SUMMIT POINTE PLAT
TRAFFIC IMPACT ANALYSIS

City of Gig Harbor, WA

Revised:
April 2023

Subject: Revisions to Summit Pointe Plat Traffic Impact Analysis

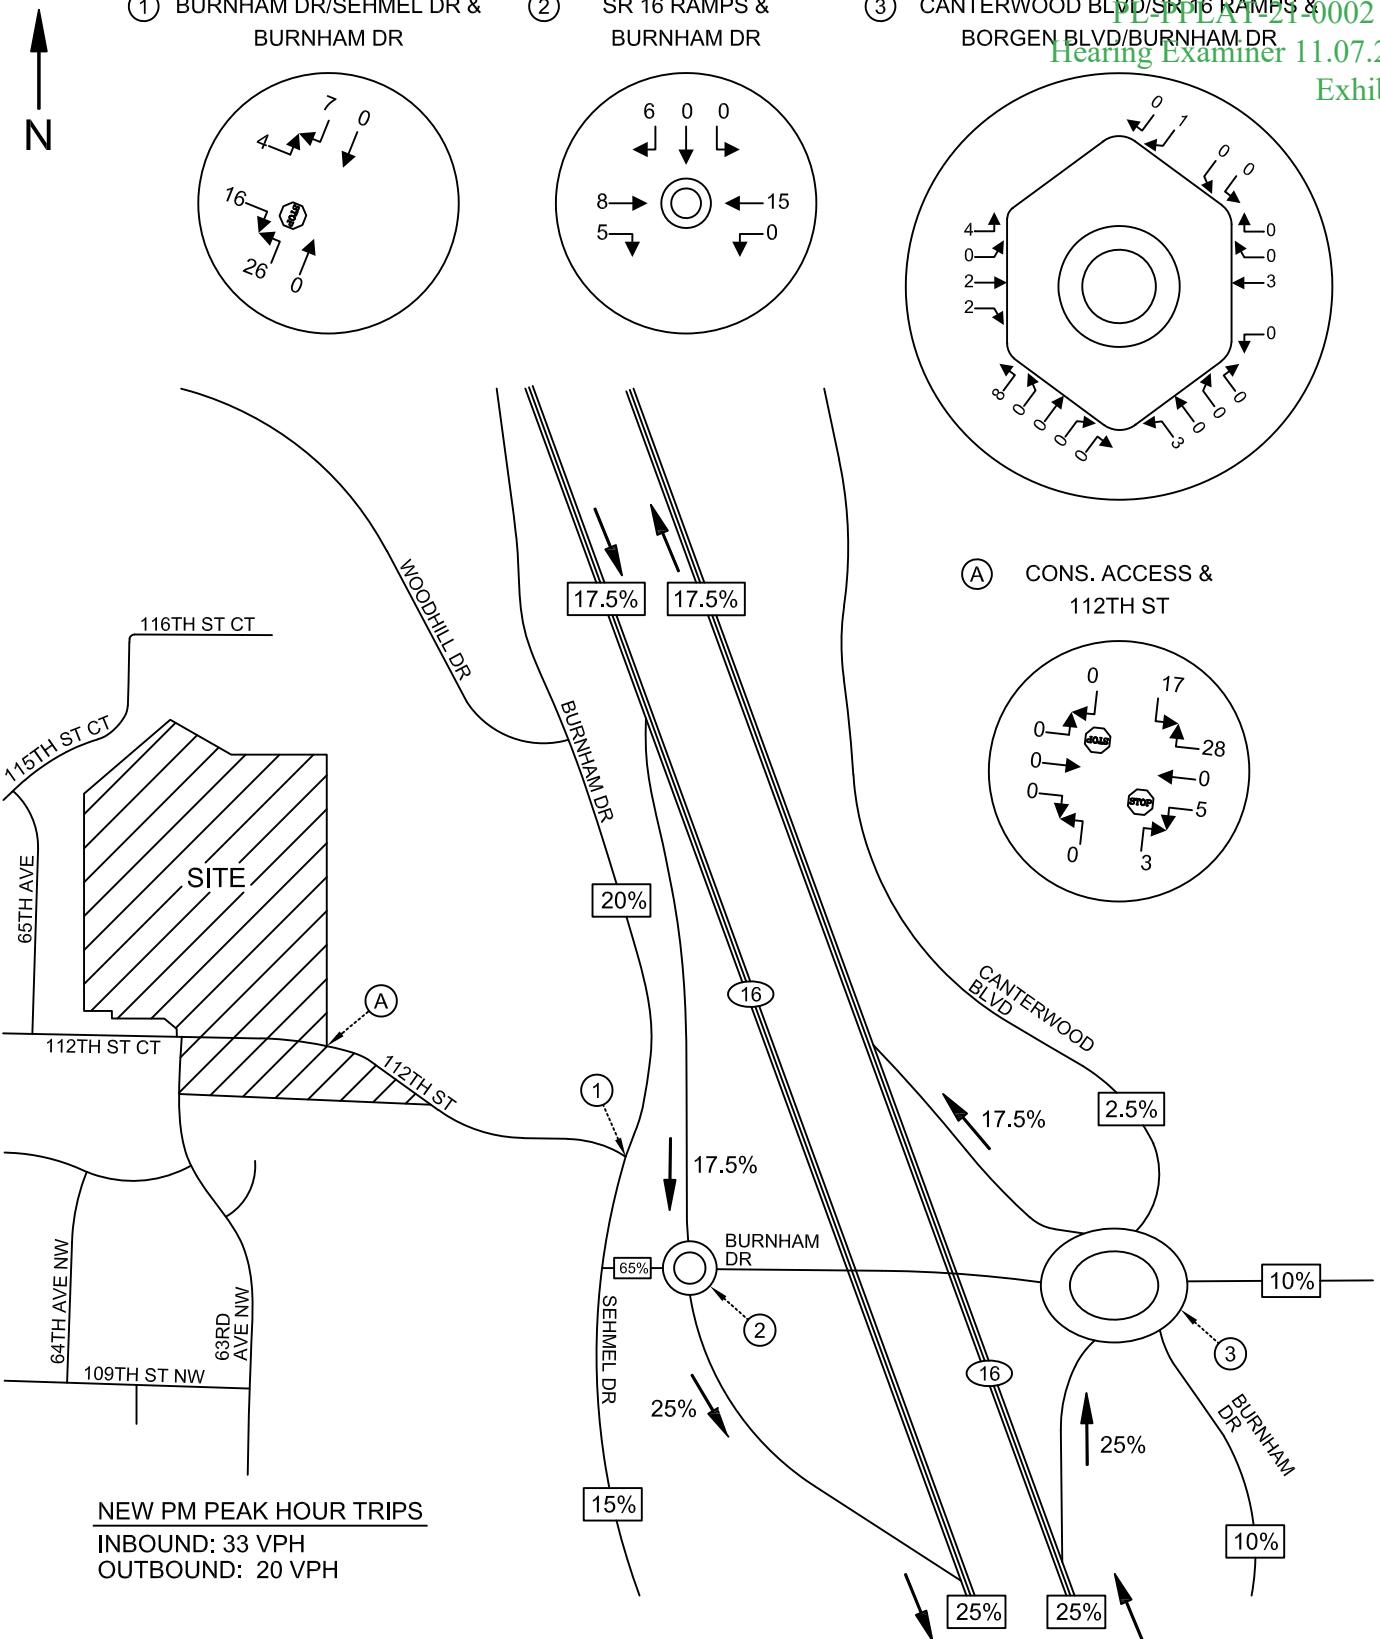
1. Comment Page 4, Site Plan: Comment acknowledged. An updated site plan is now used.
2. Comment Page 5, TIP: The TIA was updated to use the most recent 2023-2028 Transportation Improvement Program.
3. Comment Page 11, Figure 4: The TIA was updated to include analysis at the SR 16 Ramps & Burnham Drive and Canterwood Boulevard/SR 16 Ramps & Borgen Boulevard/ Burnham Drive roundabouts, as directed by the City. All Figures, narrative and calculations have been updated accordingly.
4. Comment Page 15, TIF: The narrative regarding the TIF was updated to include the calculation format requested by the City.

Figure 4 illustrates the PM peak hour trip generation and distribution for the project's generated trips. The nine lots on the south side of 112th Street were allocated and evaluated as a south leg to the access intersection.
